## **Addendum # 4**

### **Bid Opportunity: 25-7748-RFT - St. Andrew's Public School 3rd Floor Classroom Refinishing Closing Date: Wednesday, May 21, 2025 2:00 PM**

## Addendum #4

<b>Addendum #:</b>	E-1
--------------------	-----

**3. Drawing E-203 – Second Floor Demolition & New Work Plans – Power & Systems (Issued herewith):**

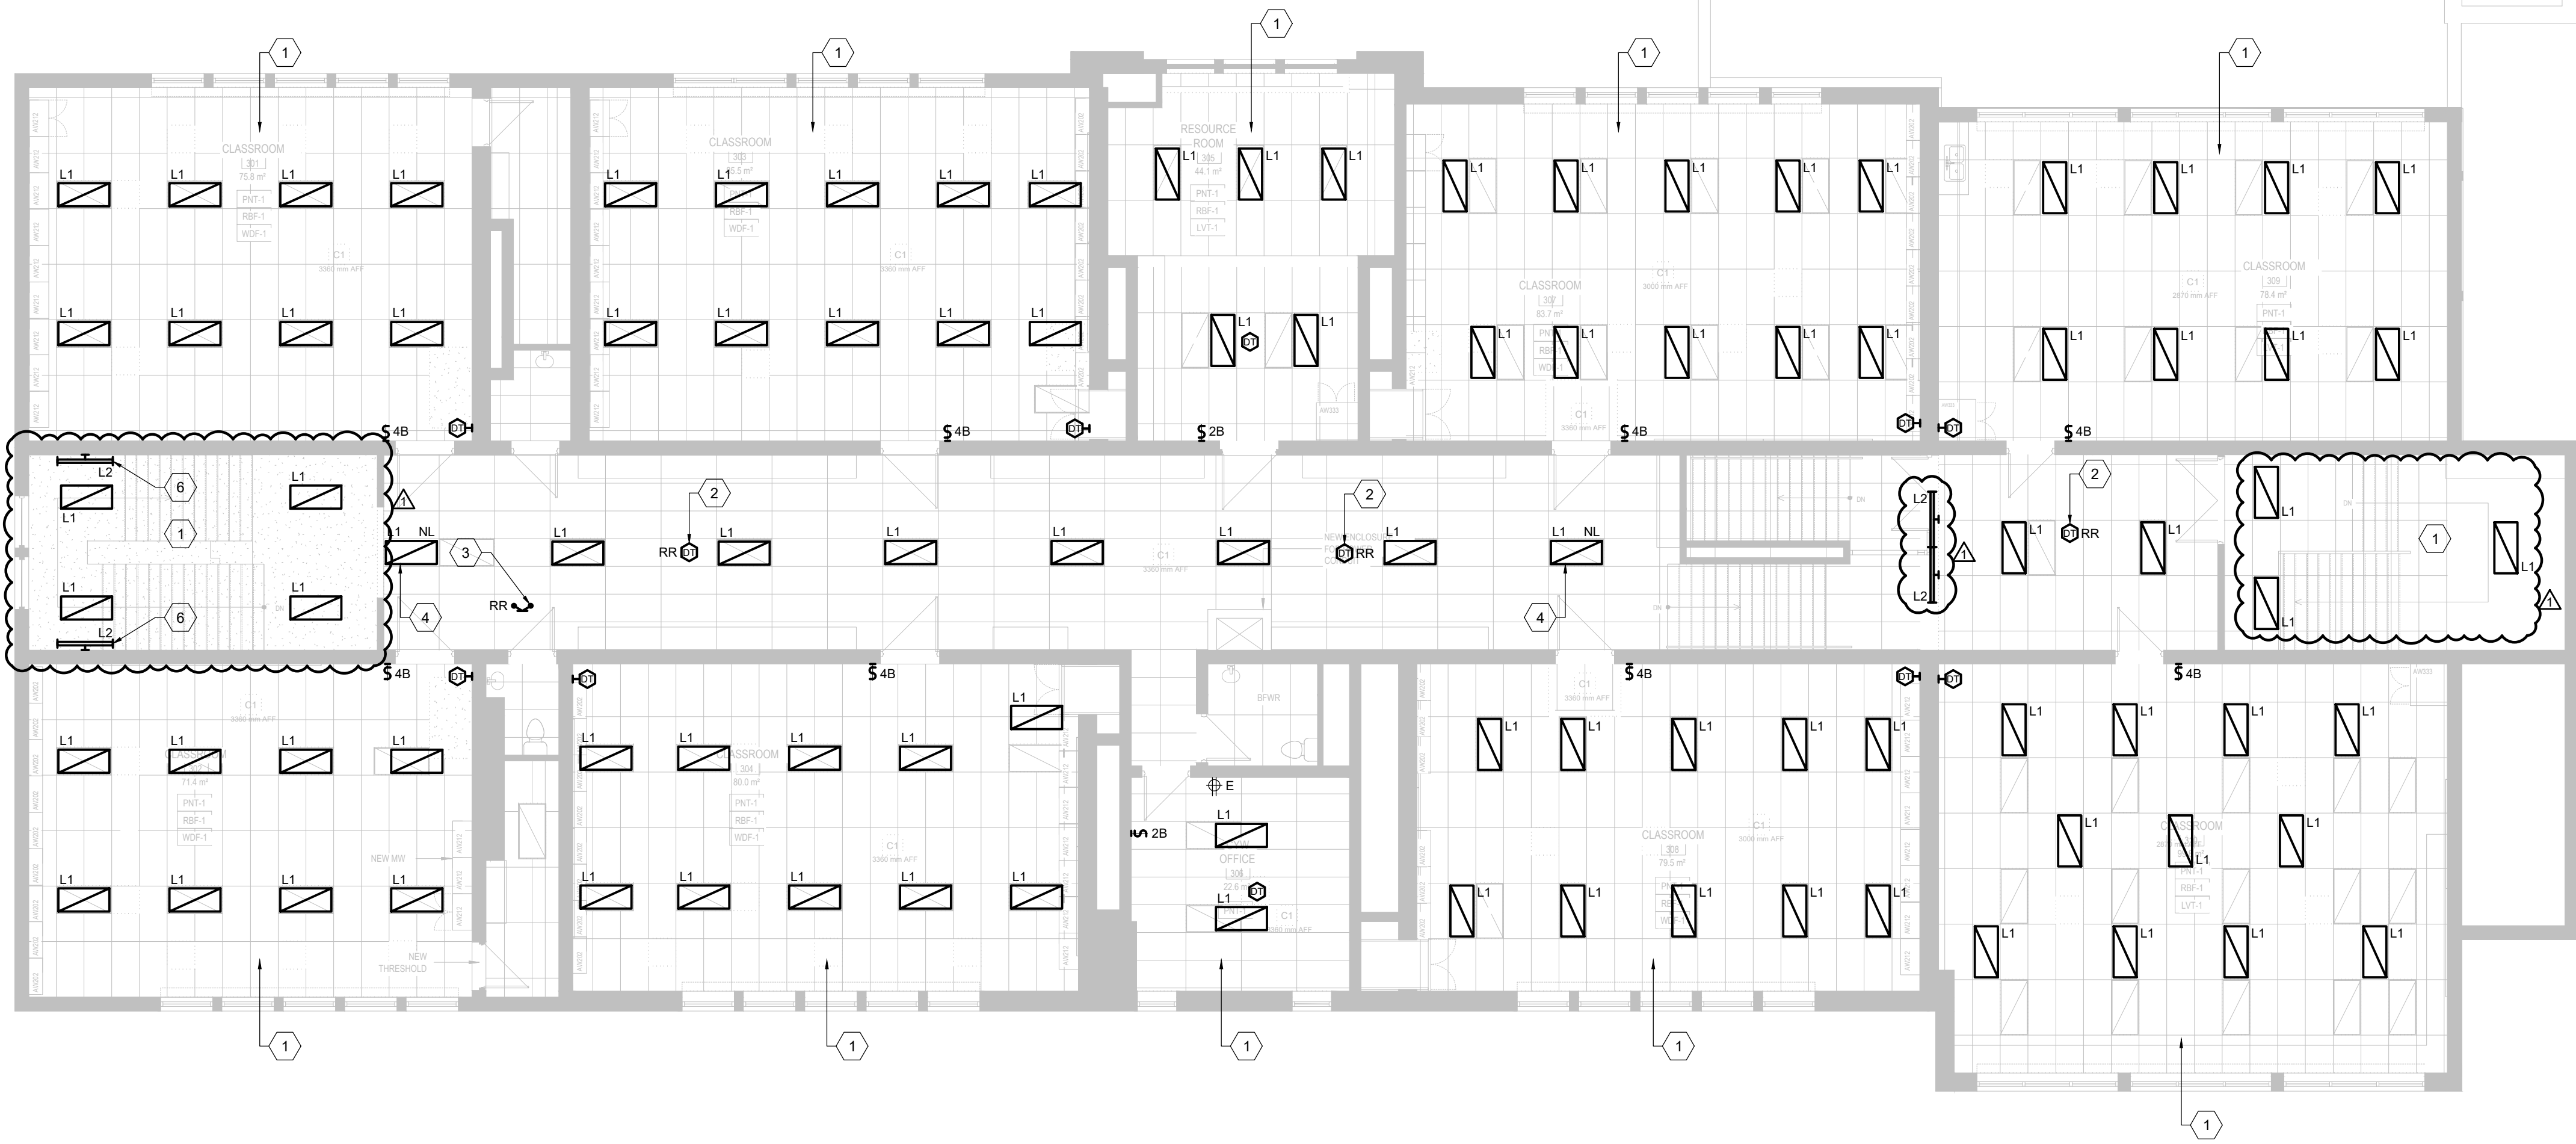
- a. Refer to attached, revised drawing #E-203 and provide all changes indicated. Modifications include, but are not limited to the following:
  1. Added Demolition Key Notes.
  2. Revised New Work Key Notes #3, #4, #5 and #6.
  3. Demolition Plan: added key note references for PA, fire alarm, WAP devices, etc.
  4. Demolition Plan: added additional removal and reinstallation of fire alarm detectors at stairwells.
  5. Demolition Plan: added existing to remain devices and existing devices to be removed to accommodate new millwork installation.
  6. New Work Plan: added existing to remain devices.
  7. New Work Plan: added reinstallation of PA, fire alarm, WAP devices, etc. for devices noted on demolition drawings.
  8. New Work Plan: added additional new receptacle devices – connect to branch circuits indicated.

E-101

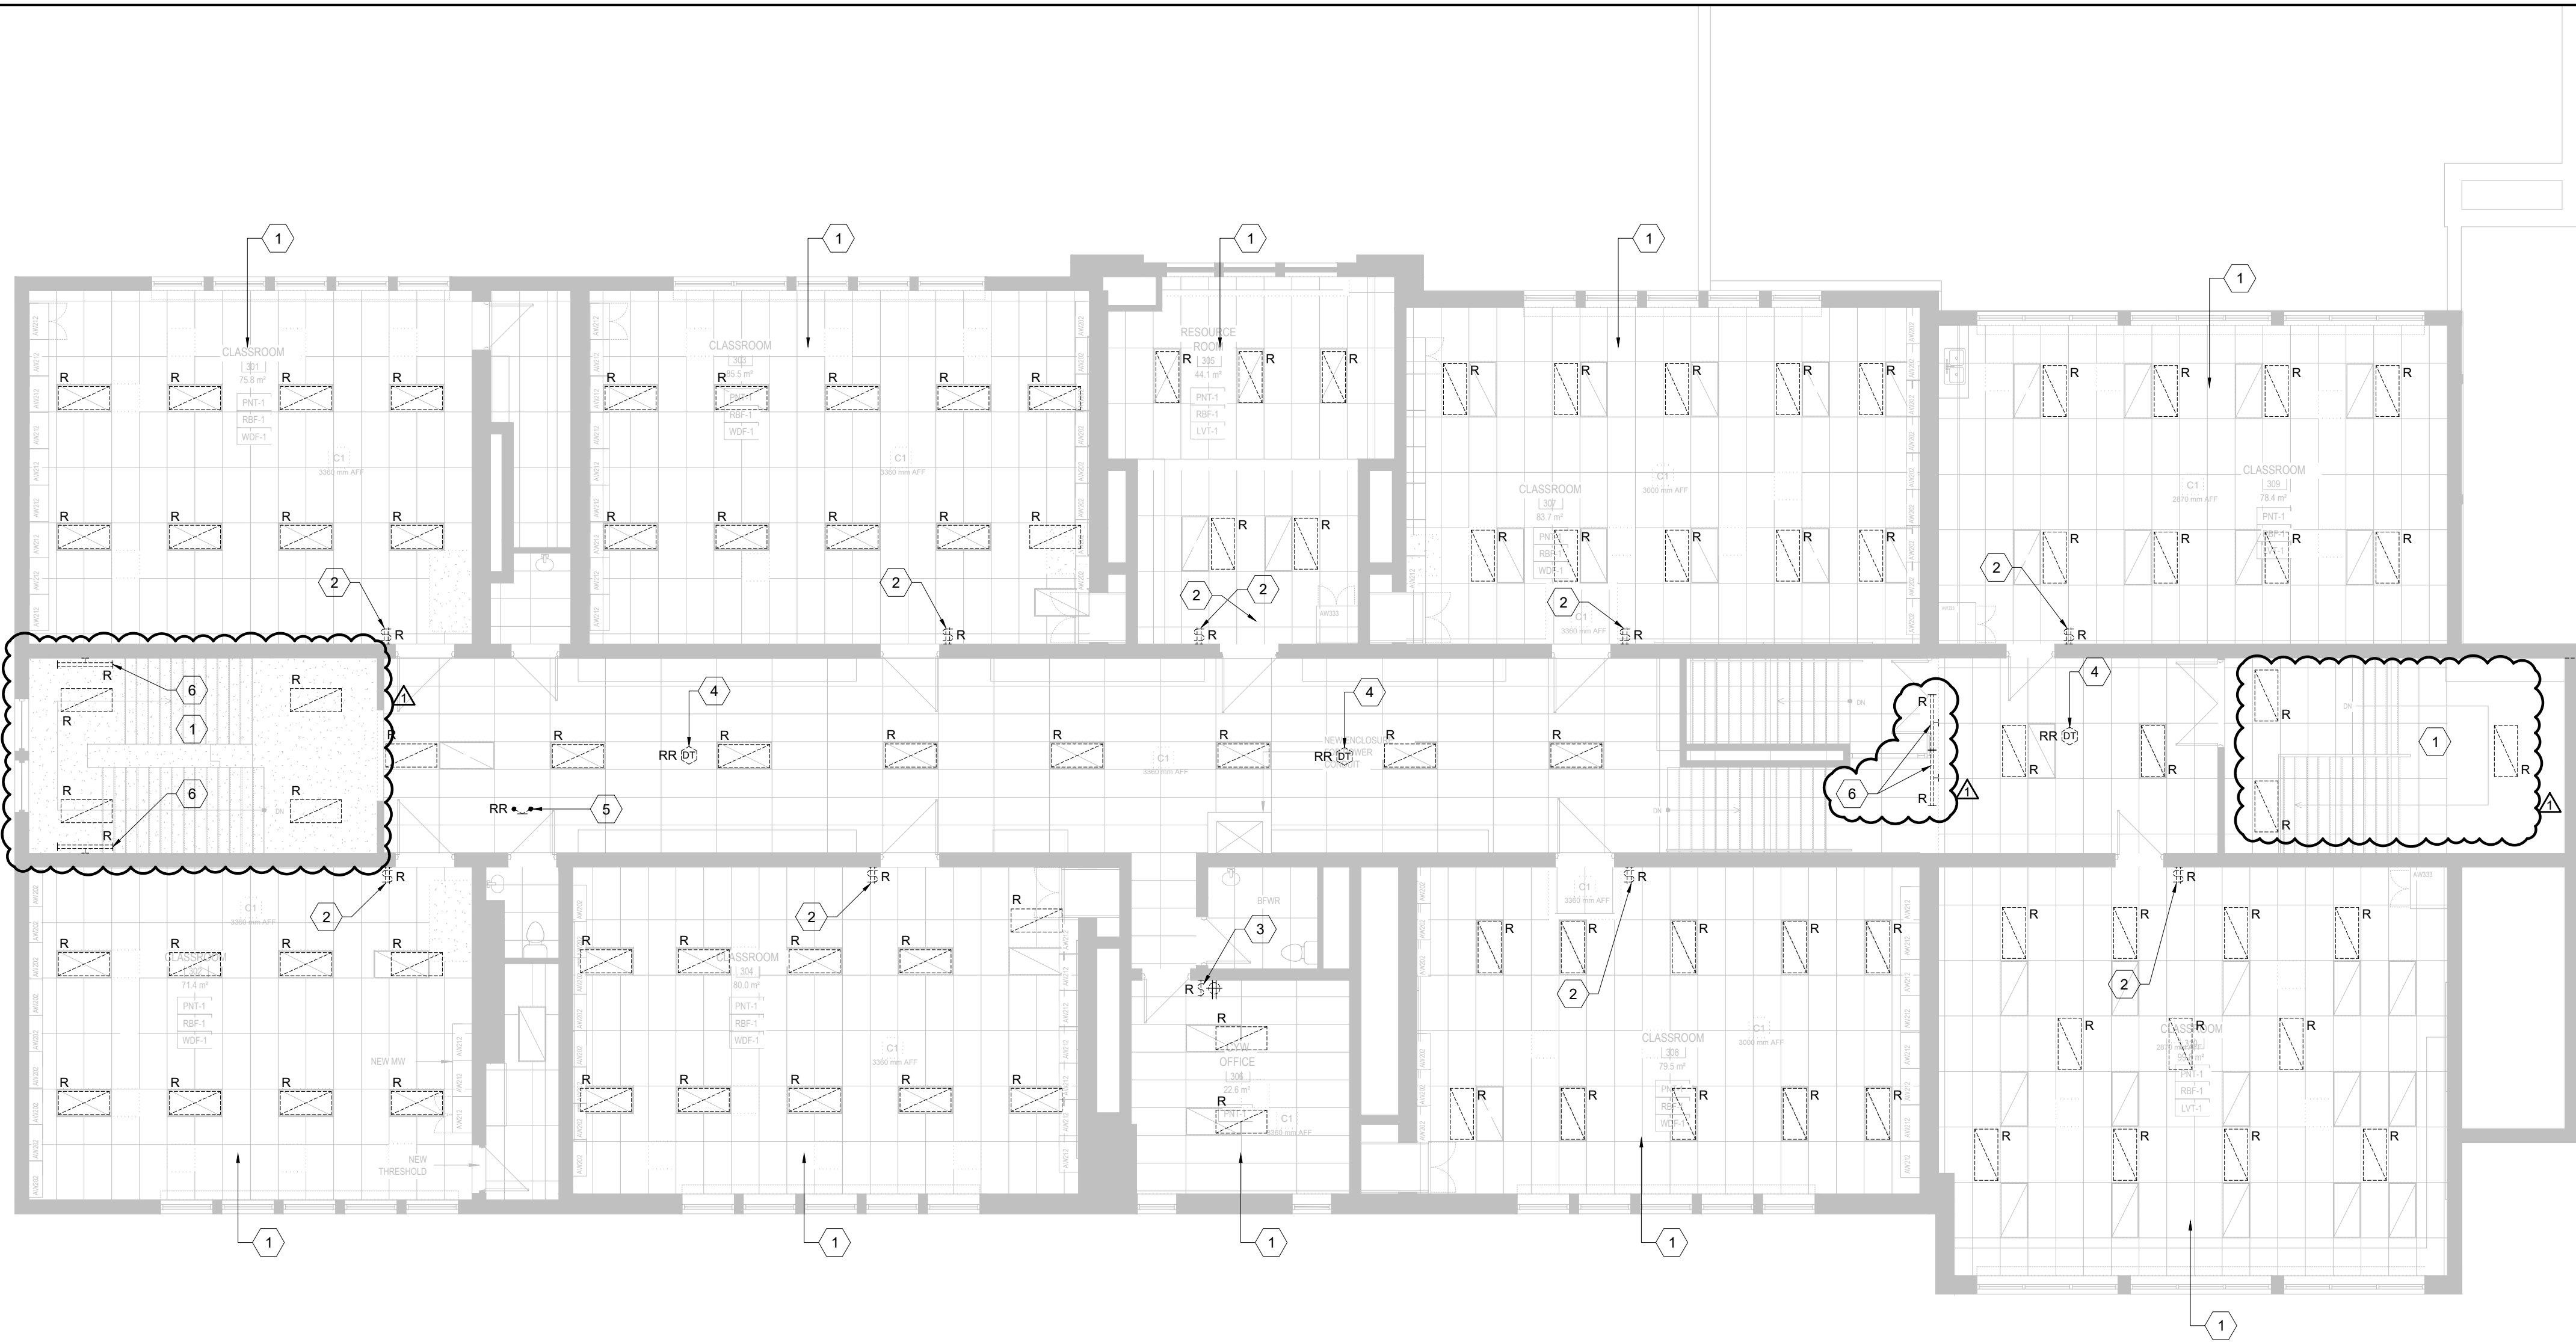
**Changes to Drawings**
**1. Drawing E-101 – Second Floor Demolition & New Work Plans – Lighting (Issued herewith):**

- a. Refer to attached, revised drawing #E-101 and provide all changes indicated. Modifications include, but are not limited to the following:
  1. Added note #6 to demolition key notes.
  2. Demolition Plan: removal of existing luminaires in existing stairs.
  3. Demolition Plan: removal of two wall mounted lights within corridor.
  4. New Work Plan: provision of new lighting within existing stairs and reconnection to existing circuits.
  5. New Work Plan: provision of new wall mounted lighting within corridor and reconnection to existing circuits.

**E-202**

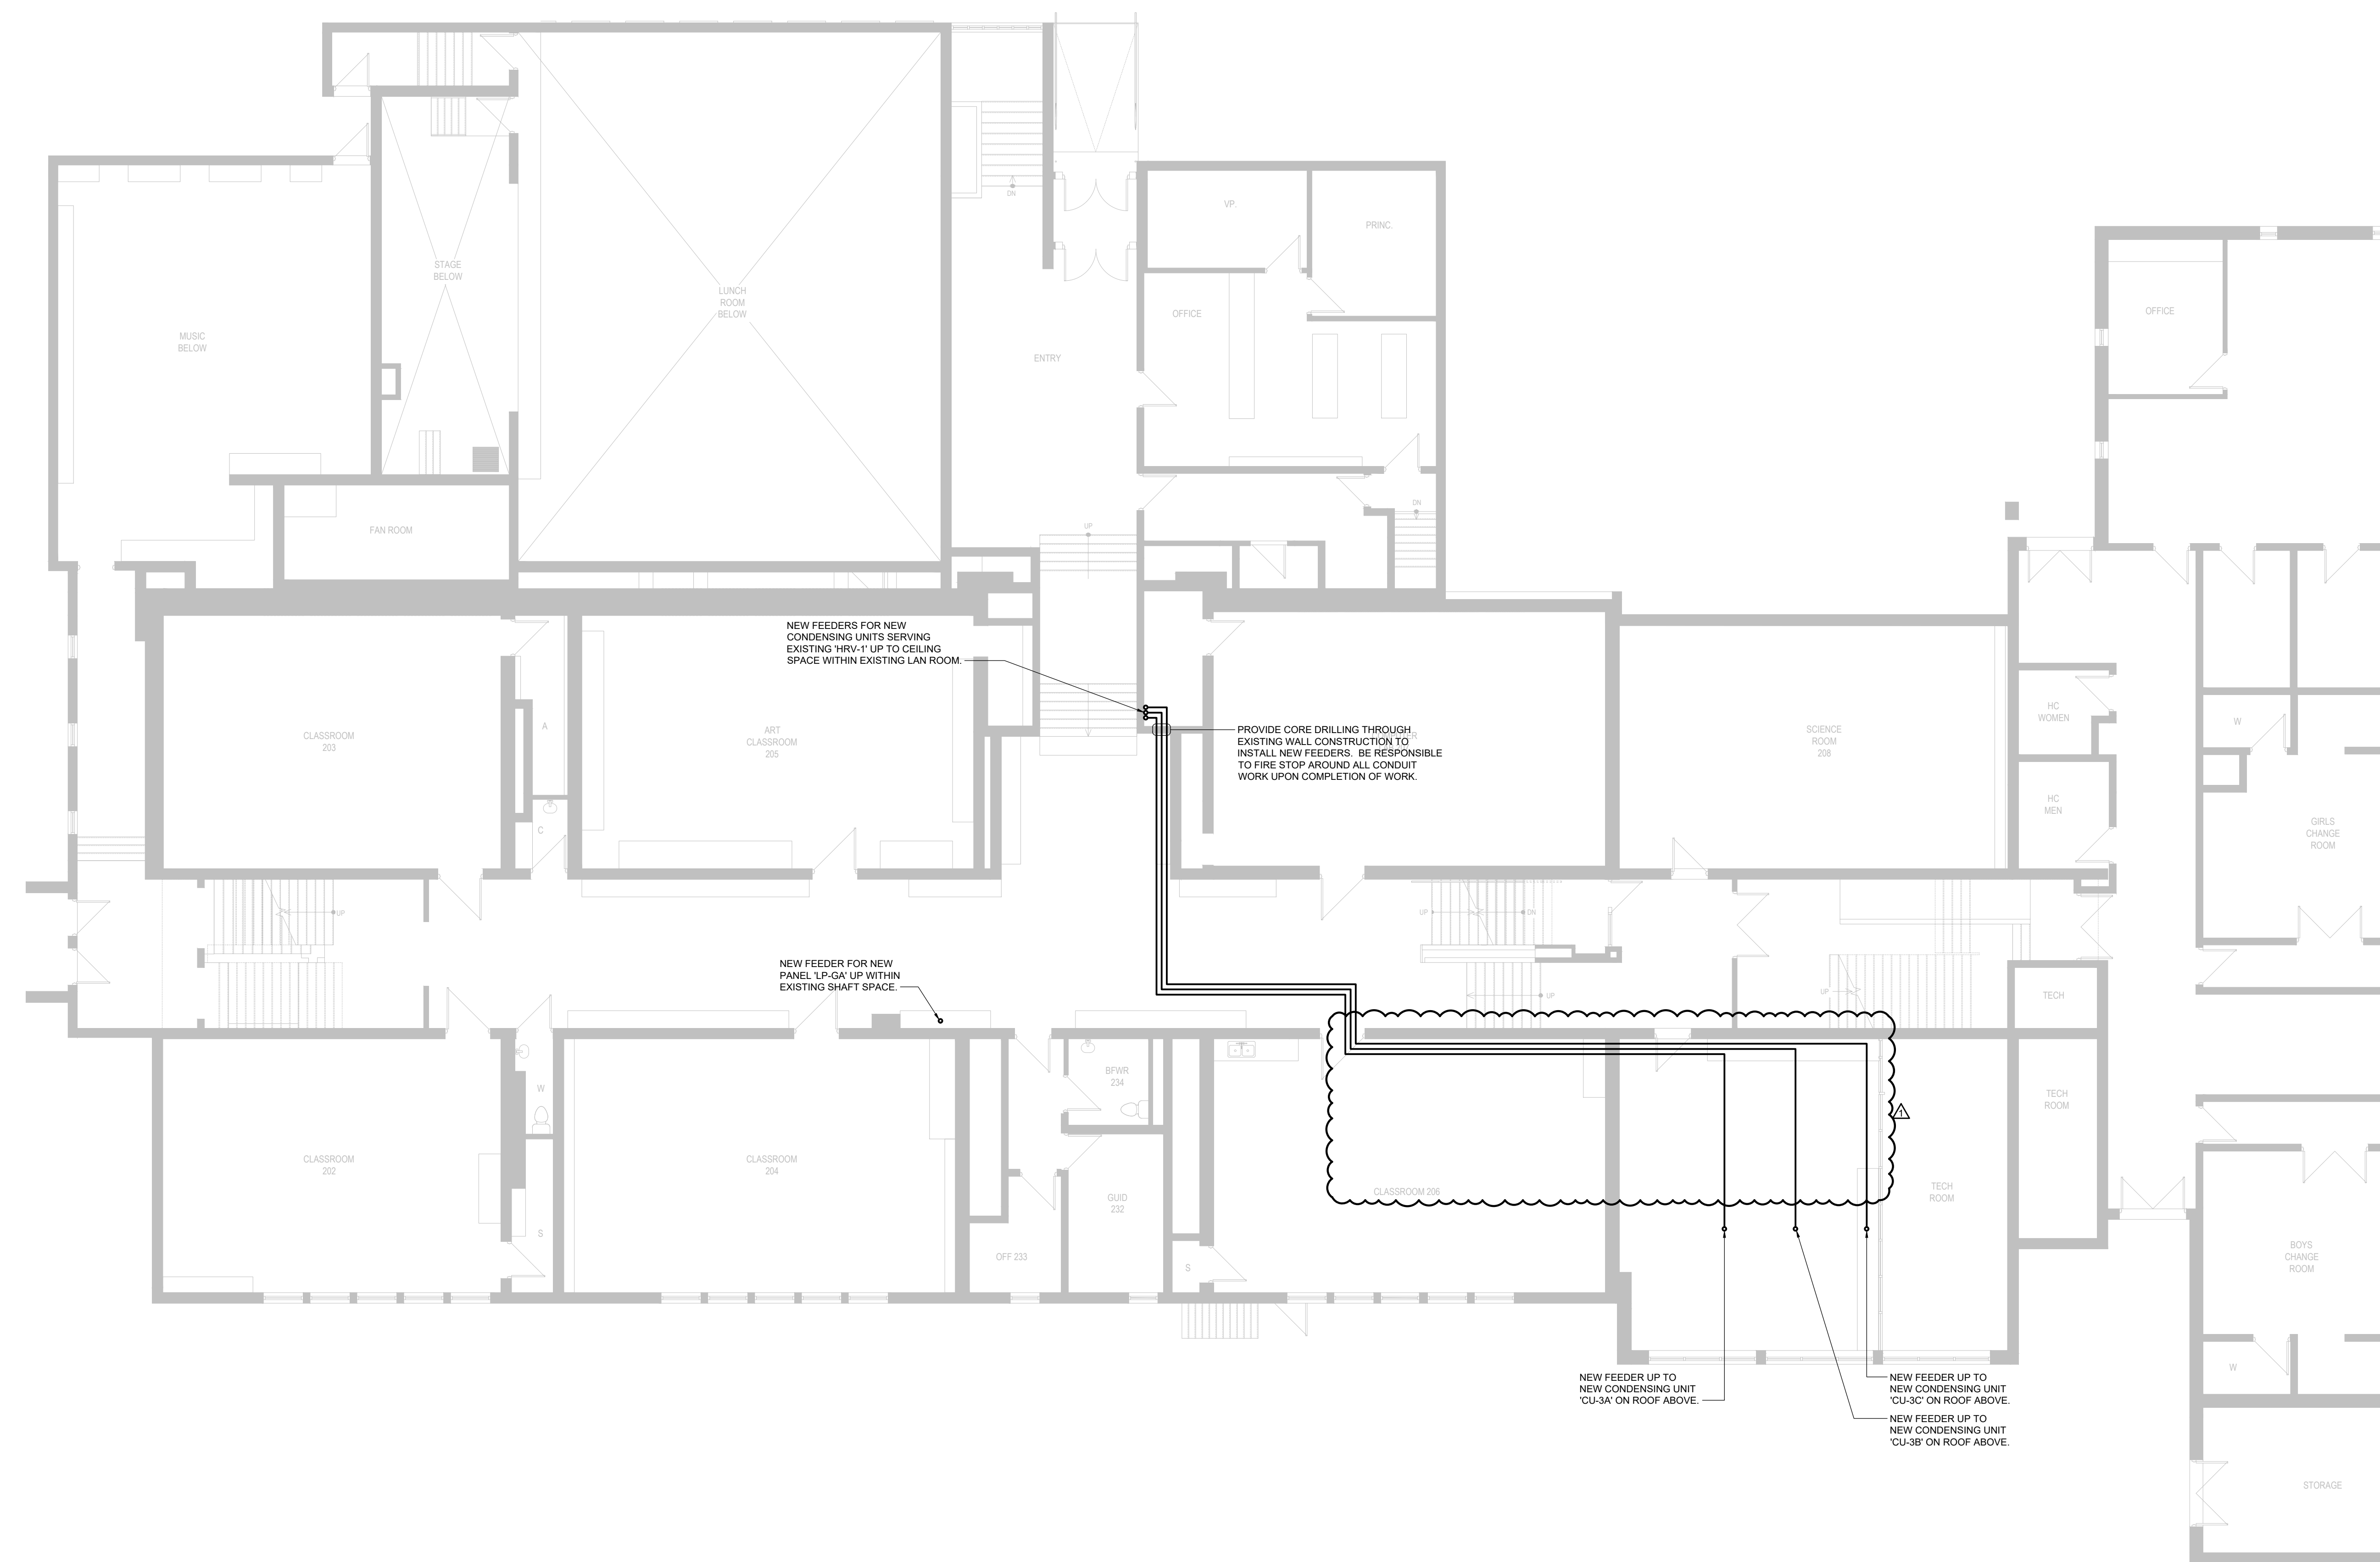
**2. Drawing E-202 - First Floor New Work Plan – Power & Systems**

- a. Refer to attached, revised drawing #E-202 and note revision to the routing of the new feeders to new roof mounted condensing units ‘CU-3A’, ‘CU-3B’ and ‘CU-3C’. Routing shown is diagrammatic and is to be confirmed on site prior to rough-in.
